AGENDA
PLANNING COMMISSION
116 WEST NEEDLES
BIXBY, OKLAHOMA
April 18, 2013 6:00 PM

STAFF REPORT

To: Bixby Planning Commission
From: Erik Enyart, AICP, City Planner *EE*
Date: Friday, April 12, 2013
RE: Report and Recommendations for:
PUD # 47-C – Woodcreek Office Park – Sack & Associates, Inc.

City of Bixby, Tulsa County, Oklahoma
Planned Unit Development Number 47-C
March 2013

Landscape Concept
EXHIBIT 'B'
 Planned Unit Development Number 47-C

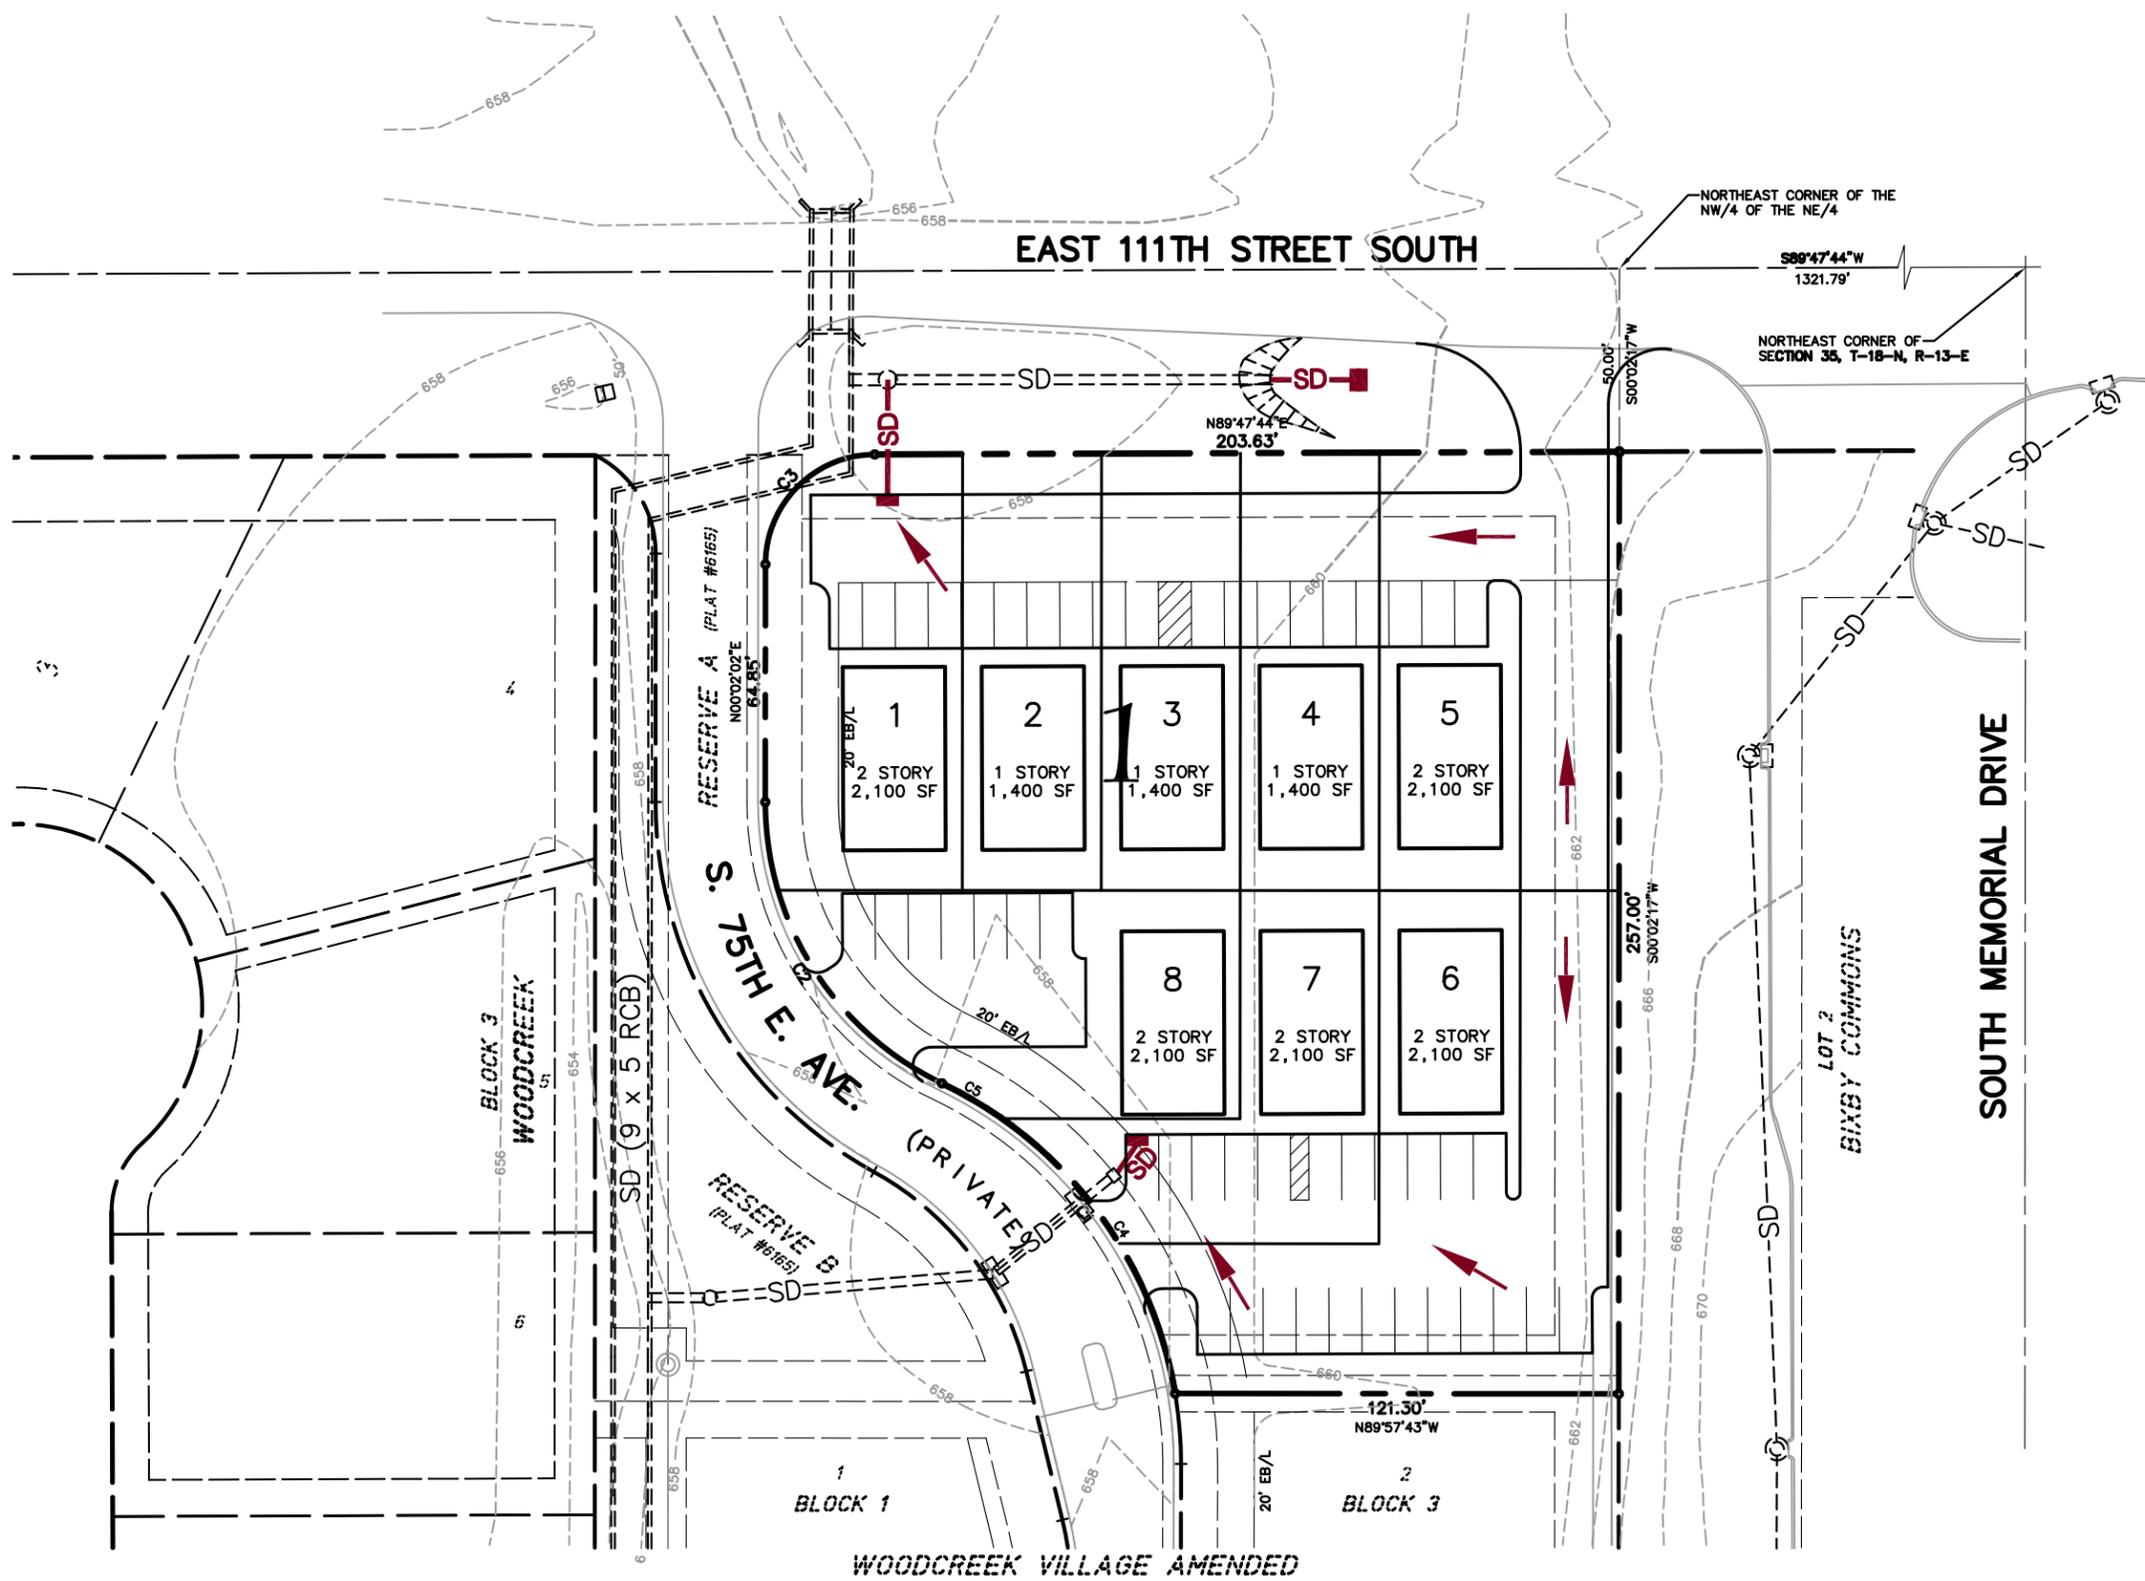
30. Exhibit B Landscape Concept: Add to Required Landscape Summary something general speaking to the minimum required landscaping tree requirement such as, "1 Tree per 1,000 square feet of Street Yard area and 1 Tree per 1,000 square feet of Zoning Setback area."
31. A corrected PUD text and exhibits package shall be submitted incorporating all of the corrections, modifications, and conditions of approval of this PUD (2 hard copies and 1 PDF).

Circulation Plan
EXHIBIT 'E'
 Planned Unit Development Number 47-B

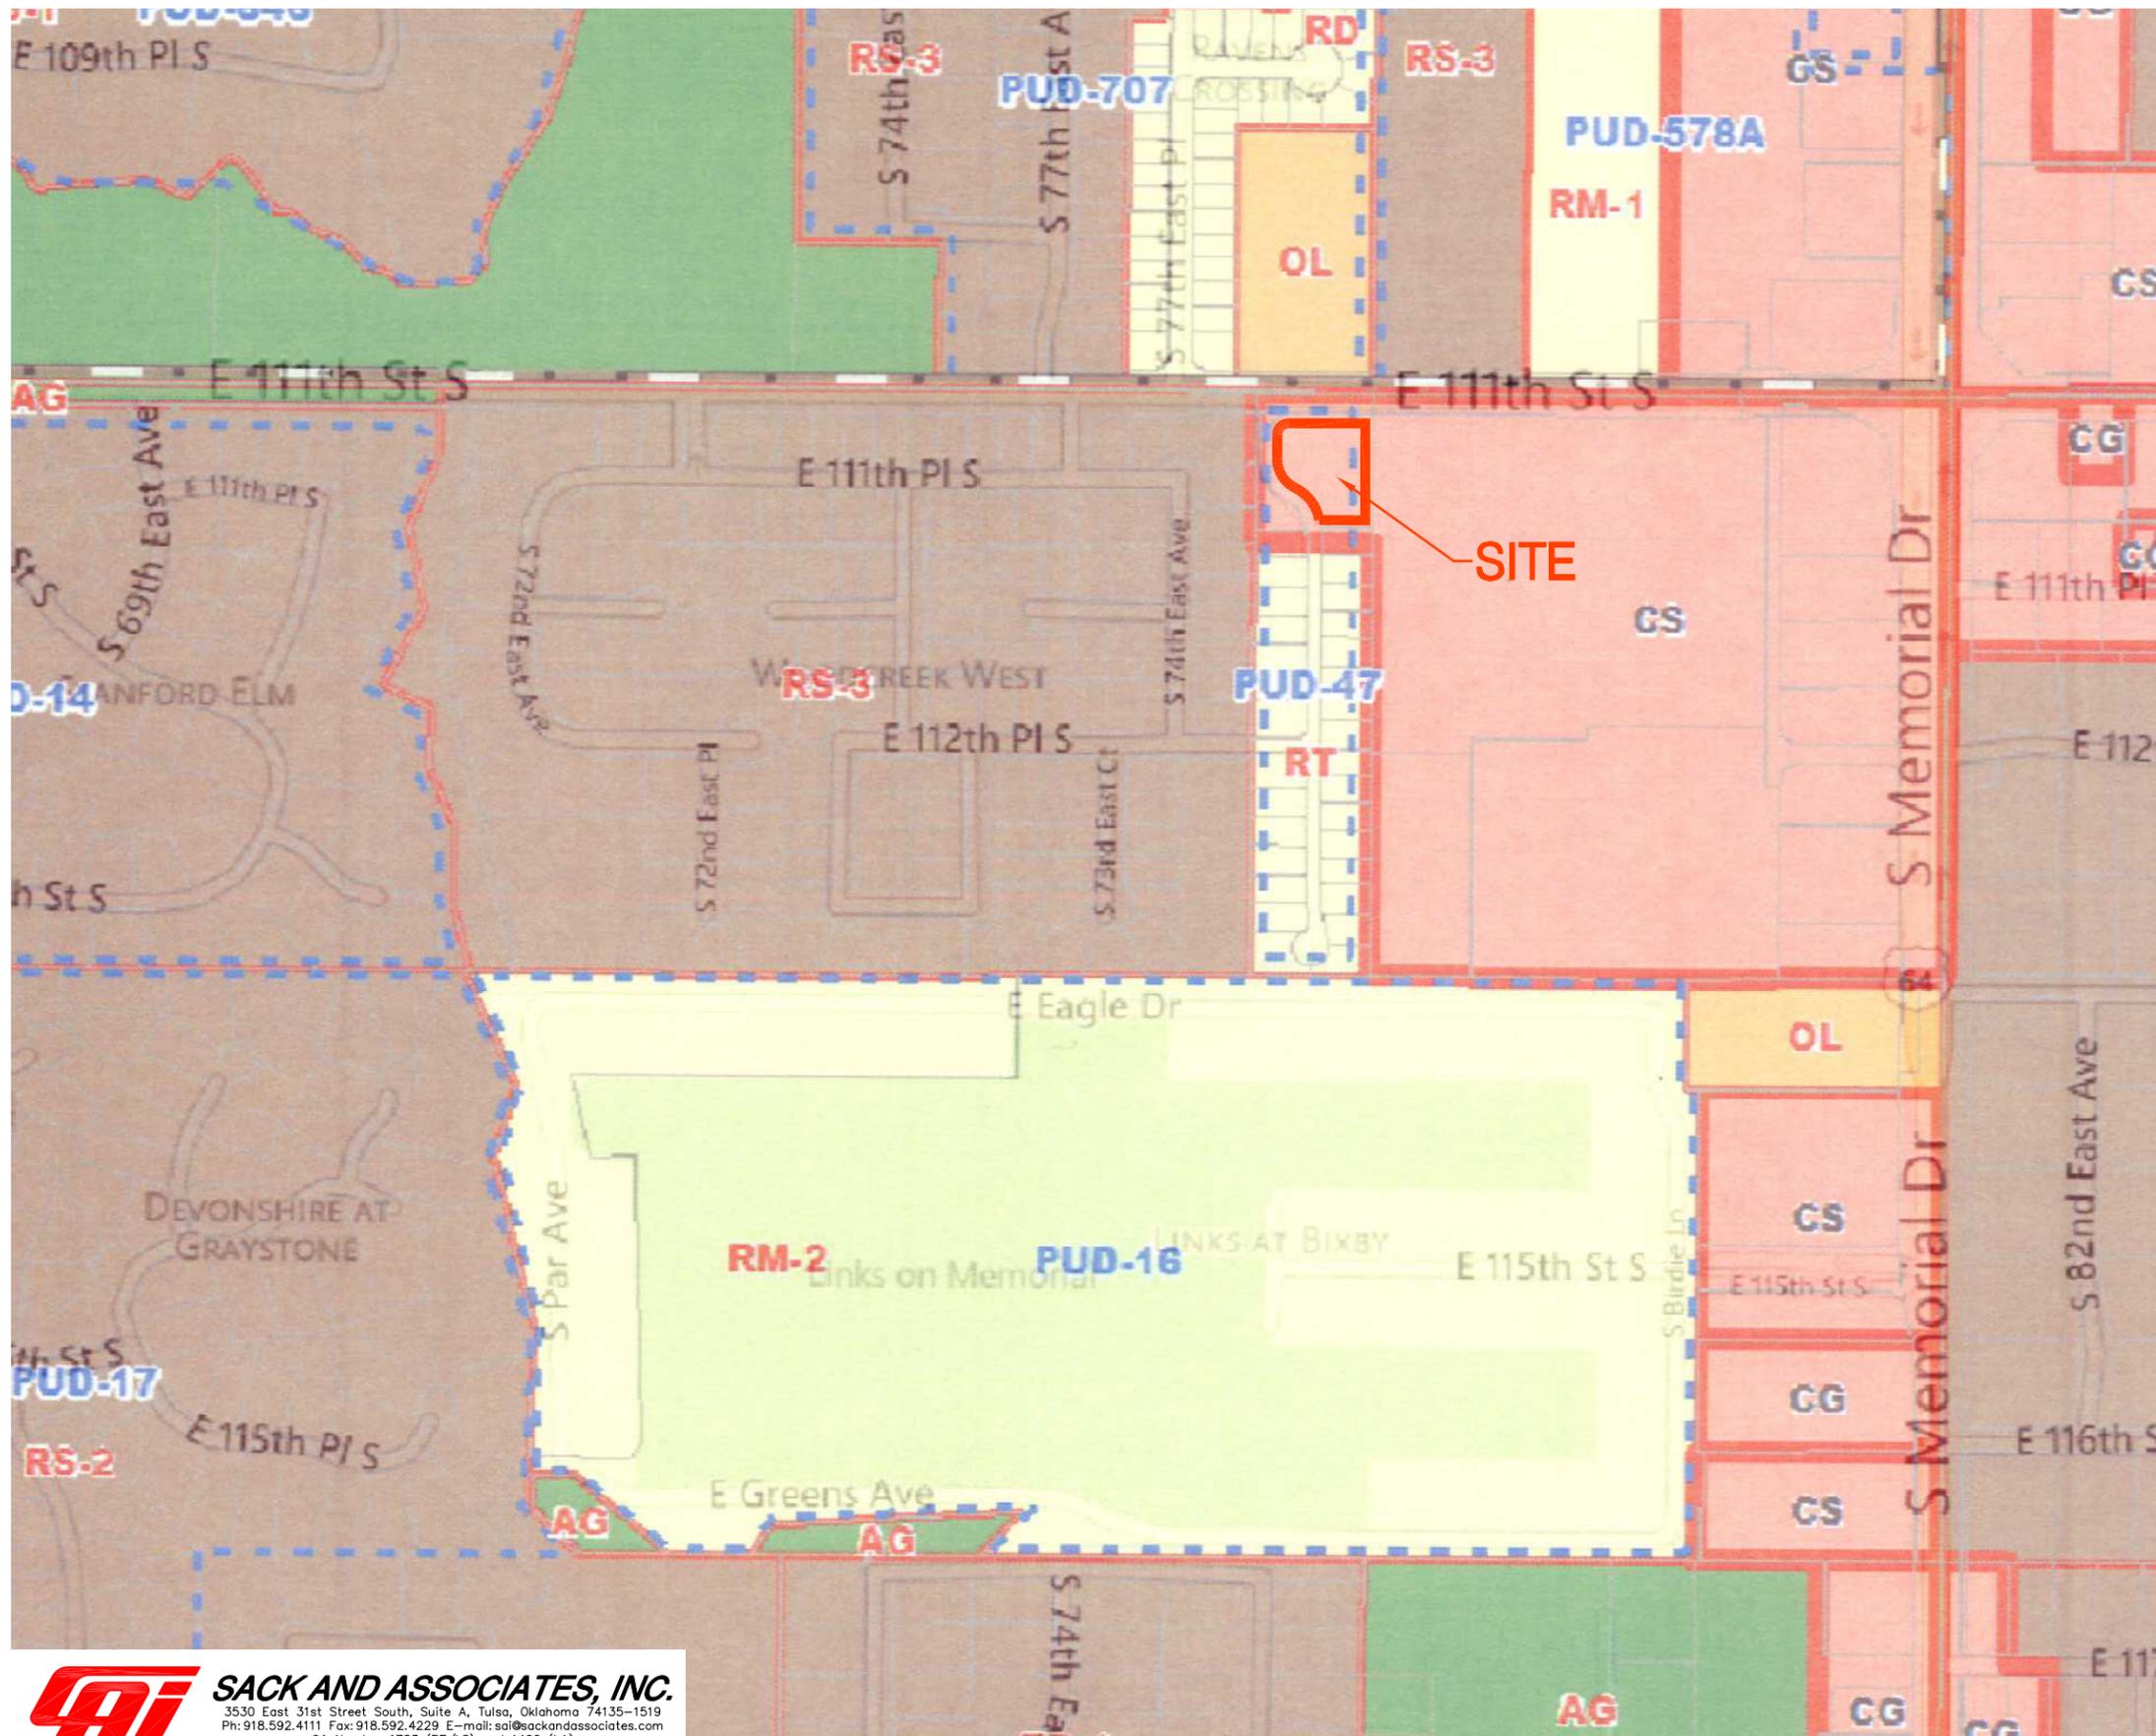
23. Exhibits: Building sizes and setbacks need to be dimensioned on the site plans, so that math, scaling the site plan, and/or "guesstimation" are not required for zoning, Fire Marshal, and City Engineer review. Site plan can be qualified as "conceptual only" as needed.
